CHANGE ORDER APPROVAL FORM

PROJECT: Loop Road - Phase 1

CHANGE ORDER NUMBER: 1

REQUEST FOR CHANGE ORDER

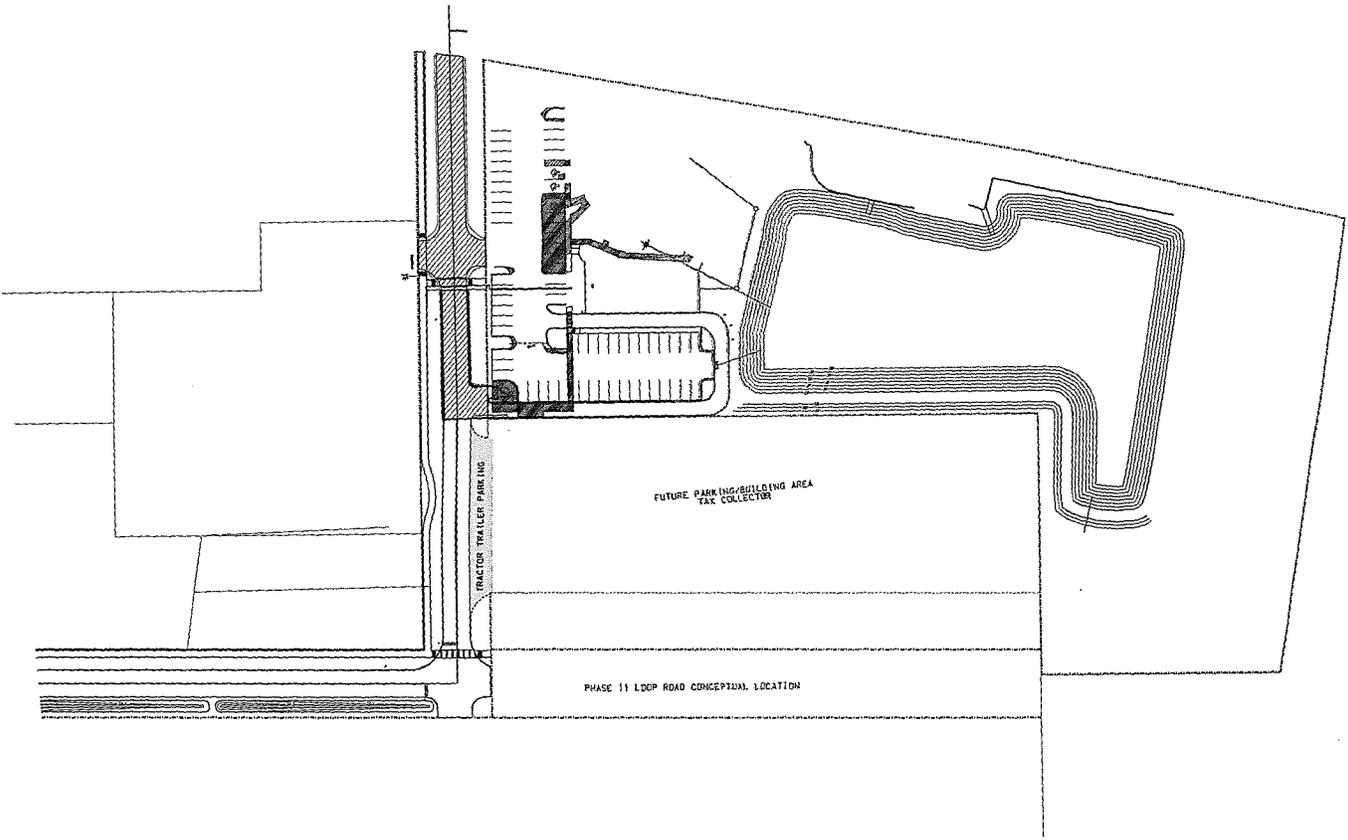
We've calculated the following based on an additional 186 sy of pavement and using the same FDOT pay item data used for the first Loop Road estimate. We have added 50 LF of curb and gutter to ensure stormwater flow is maintained within the paved area and is transferred to the existing stormwater collection system. We used FDOT estimates per foot for this, but for such a small job, it may not be quite applicable.

We will issue new plans on this in the coming days. This also considers a credit for a portion of parking area near the former recycling facility that will not be installed:

Sub-base	186 sy@ \$9.00	\$1674
Base	186 sy@ \$13.50	\$2511
Asphalt	16 tons @ \$81.44	\$1303.04
Curb & gutter	50 lf @ \$13.65	\$682.50
Total		\$6,170.54
